PRPTP Firmware Release Notes

VERSION 3.15r8

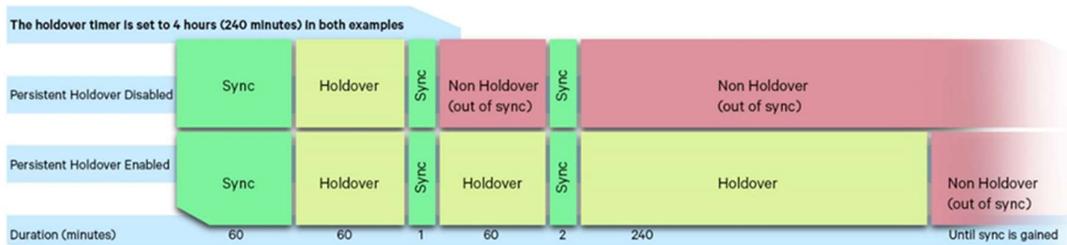
- **Feature:** Added support for enabling the persistent holdover availability option. Tekron Configuration Tool 4.2.1.10 or later is required to enable this option.

Normally, the clock can only enter holdover if it has been in sync for at least 5 minutes. If persistent holdover is enabled, and the clock has initially been in sync for at least 5 minutes, then the clock can still enter holdover if it experiences a sync switching condition. For example, sync is lost, regained for less than 5 minutes, then lost again. Such a condition may exist when GNSS jamming is present, or in the case of a poor antenna installation.

Please note, when entering holdover after a period of intermittent sync the holdover period timer is reset. This may cause the clock to enter an extended holdover period, if the sync switching condition continues to be present. By disabling persistent holdover, you can ensure that the time in holdover is not extended by periods of intermittent sync lasting less than 5 minutes.
